Unofficial Comment Form

Project 2010-17 Definition of Bulk Electric System Phase 2 | First Draft

Figure 1

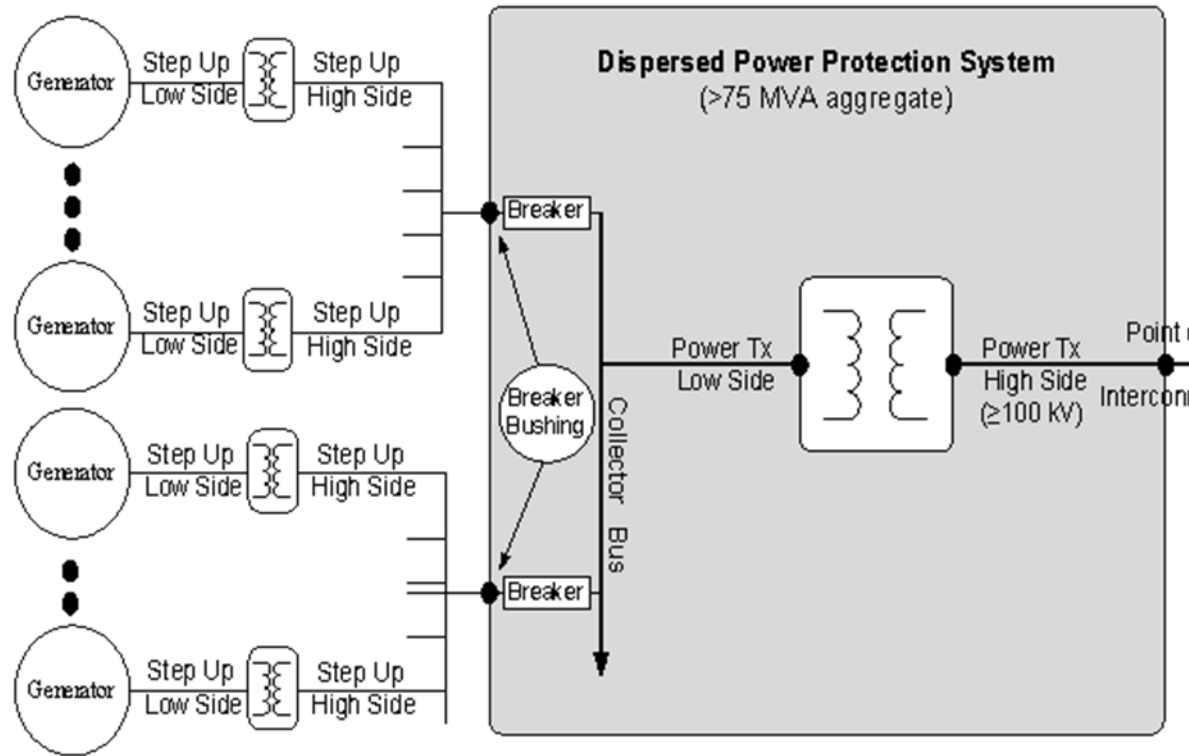
In plants with an aggregate rating greater than 75 MVA, the individual generators should be treated in the same manner as if they were each a stand-alone facility. If the individual generator is at or below 20 MVA in a stand-alone facility it would not be included in the BES and the owner of such a facility would not even have to register as a generator owner. That same size generator in an aggregated facility should be treated the same and it should be excluded from the BES. The portion of the facility at which the 75MVA or greater aggregation occurs should be where the BES boundary should be occurring.

Below is a sketch to demonstrate the concept:

See Figure 1.
